**Re: SSD-48028209**  
**State Significant Development for Seniors Housing**  
**Opal St Ives Care Community**

We object to the proposed development SSD-48028209 (**the proposal**) in the manner and for the reasons set out herein particularly in respect to amenity and non-compliances in the proposal.

*Above: Sketch showing approximate locations of existing sections of fencing and unfenced boundary.*

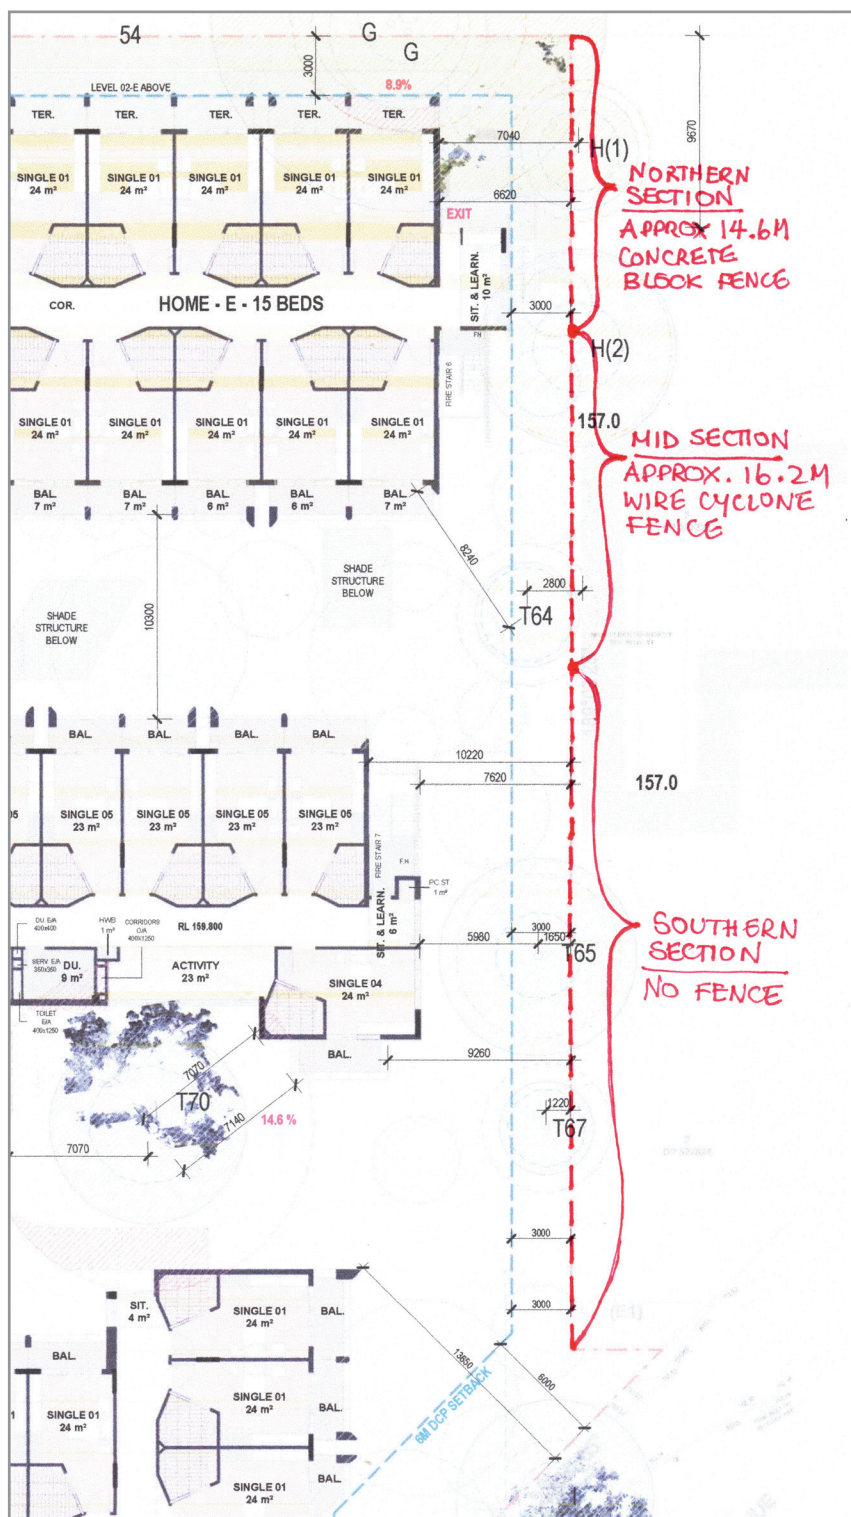
**NORTHERN SECTION:**  
**14.6m**  
**(approximately)**  
**concrete block fence**  
(stepped in height,  
mostly 1.7m tall).

**SOUTHERN SECTION:**  
**No fence.** Privacy comes from the tall wire tennis fence covered in vines. There are a number of old camellia trees which are planted roughly on the boundary line.

### The Section AA On Page DA3100 is incorrect.

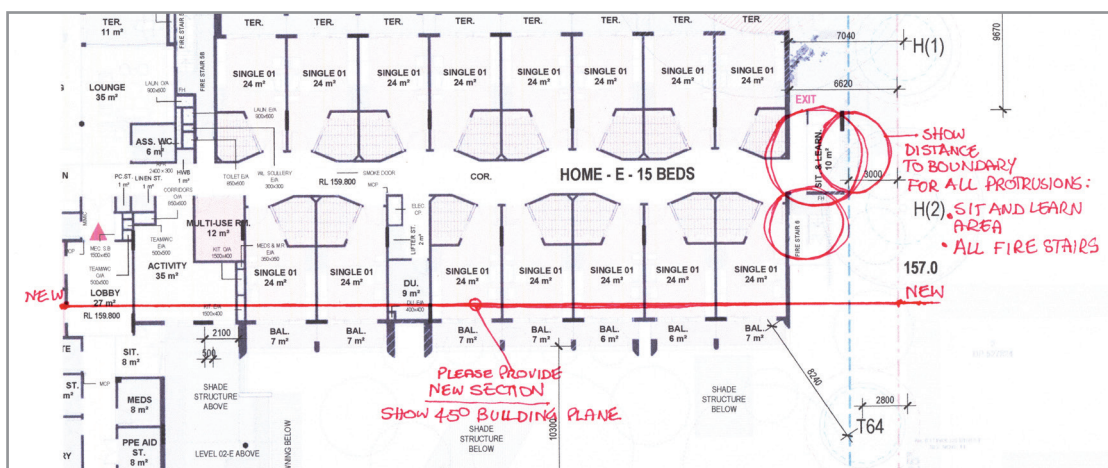
There is no fence at this point on the boundary. Please provide an accurate drawing.
